PUBLIC COMMENT SUMMARY SEATTLE COMMUNITY DESIGN PROCESS REPORT

NOVEMBER 2012

Washington State
Department of Transportation

Portage Bay Bridge Area

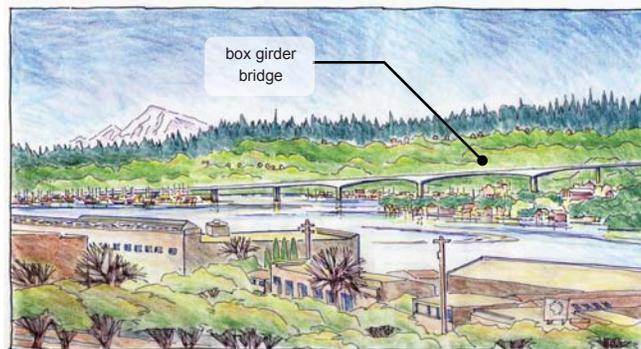
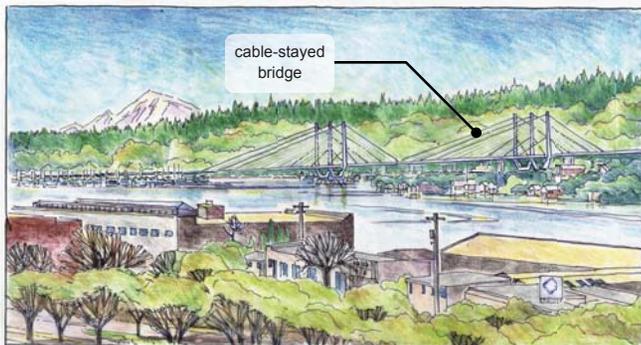
6 Bridge alignment

Support to shift bridge alignment to the north on the west end of the bridge for shorter construction duration.

(Approximately 141 of 345 individual comments support this preference.)

- Of the remaining 345 comments, 87 indicated they were neutral or had no preference towards an alignment shift and 34 were specifically opposed to this preference.

7 Bridge type

Support to proceed with further technical analysis and refinement for box girder and cable-stayed bridge concepts. Explore ways to integrate the structure with the surrounding neighborhoods.

(Approximately 175 of 366 individual comments support this preference.)

- Requests for more information on the bridge concepts including, possible variations, overall footprint, visual aesthetics above and below the bridge deck, and cost for each concept.
- 7a • No clear consensus on a preferred bridge type.
 - » Box girder concept.
(Approximately 308 comments in support and 98 comments against.)
 - » Cable-stayed concept
(Approximately 340 comments in support and 106 comments against.)

8 Bicycle and pedestrian connections

Support to include a 14-foot regional shared-use path on the Portage Bay Bridge.

(Approximately 1,298 of 1,339 individual comments support this preference.)
